D868UV firmware update V1.24 and V2.24

V1.24 and V2.24 Improvements (dated 2018-2-1)

How to know your firmware version

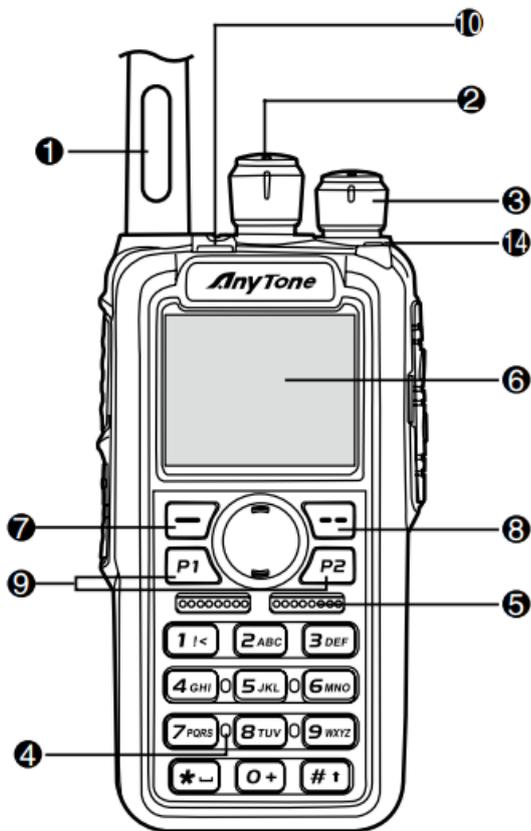
Press 7  (Menu) key to enter the menu, press  key to the Device Info and enter into the menu to check the hardware version.

Hardware V1.0 --- Please use the firmware V1.xx for updating the radio.

Hardware V1.1 --- Please use the firmware V2.xx for updating the radio.
